CARL GOLDBERG PRODUCTS, LTD.

PITTS P-12 MONSTER EP PARK FLYER ARF

SECURING NYLON INSERTS

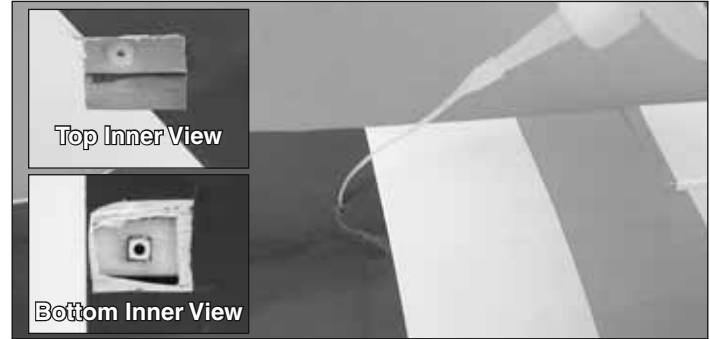
It has come to our attention that the four nylon cabane strut inserts inside the upper wing mounting plate may not be as secure as needed. We've included four #2 x 3/8" Phillips screws and ask that you take these steps in place of steps 4 and 5, on page 14 of the manual.

❑ 1. On the underside of the wing, use a hobby knife to remove the covering from the four dimples that locate the cabane strut attachment points. Be careful not to insert the knife tip more than 1/8" into the dimple. (Do not use the drilling method mentioned in step 4 as this could dislodge the insert.)

❑ 2. Using medium CA insert the CA tip 1/8" into the dimple. Next, squeeze a small amount of CA into the wing. (This is also a good time to add CA to the four strut inserts on the bottom of the upper wing and the top of the lower wing.) After you have completed this on all four dimples turn the wing over to allow the CA to cure or harden and properly secure the nylon insert.

❑ 3. Use the four #2 x 3/8" screws (included) in place of the #4 x 1/2" screws to secure the cabanes.
